DEPARTMENT OF THE ARMY JACKSONVILLE DISTRICT CORPS OF ENGINEERS P.O. BOX 4970 JACKSONVILLE, FLORIDA 32232-0019

PUBLIC NOTICE

Permit Application No. SAJ-2010-02881

<u>CHANGES</u>. The enclosed drawings describe changes since the Public Notice dated November 19, 2010. The pipeline has been relocated in several locations. The construction right of way has been reduced to 60 feet in wetlands and selected forested areas. The drawings also now indicate the locations where the pipeline will be installed using HDD instead of by an open trench. HDD includes the use of drilling mud. The design of the barrier surrounding HDD work pads to contain spills has been clarified. At Levittown beach, where most of the length of the beach will be HDD, a second barrier has been added. The drawings also now indicate the location of Mainline Valves (MLV) when located in wetlands. For each MLV, gravel will be placed on the wetland to provide a vegetation-free area for maintenance and access but not block water flow. To compensate for this permanent loss of wetlands, some wetlands neighboring the Caño Tiburones Natural Reserve will be enhanced.

Index Map

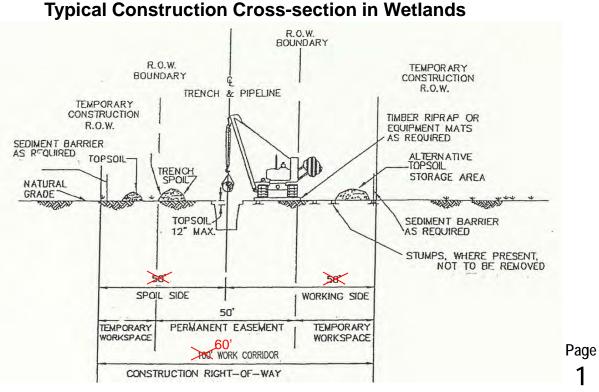
Relocated to poorer quality of vegetation. Lower potential for threatened or endangered plant species. Lower quality Puerto Rican nightjar habitat.

Relocated to an existing road to reduce impact to forest. Construction width reduced to 60 feet.

Relocated to avoid potential locations for the Puerto Rican crested toad and threatened or endangered plant species.

Relocated for an archeological site.

Page 2 of 12 pages

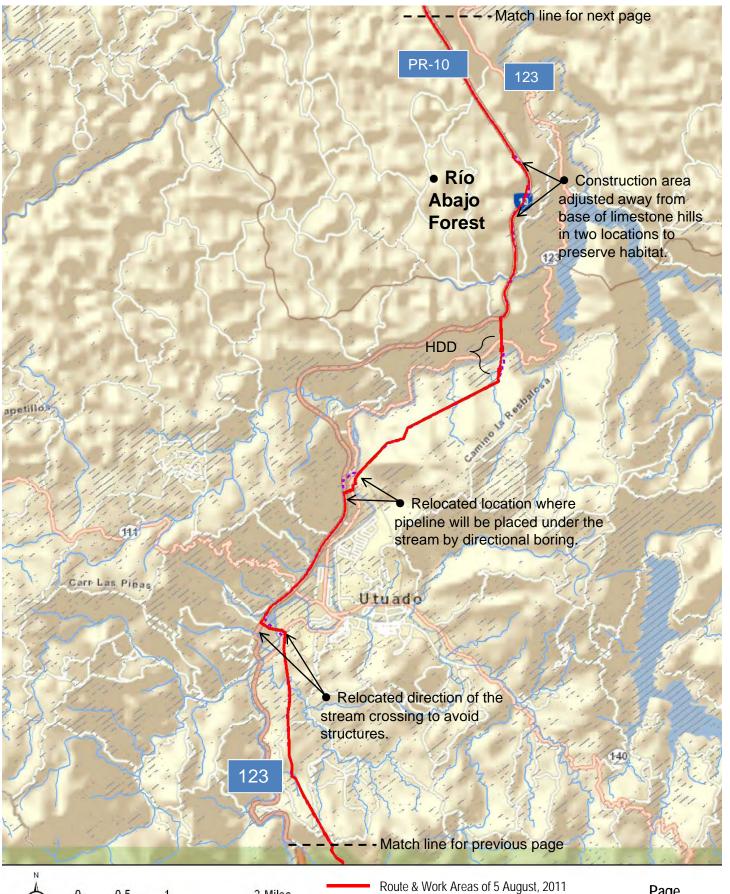
123 The dashed line is the route shown by the map in the Public Notice of November 19, 2010. The dotted line shown Adjuntas by other maps in the permit application. Subsequent adjustments to align with topography. Relocated to avoid Foreman conservation land. Further minor relocations to avoid an intermittent body of water. PR-10 123 - Match line for previous page Route & Work Areas of 5 August, 2011 2 Miles
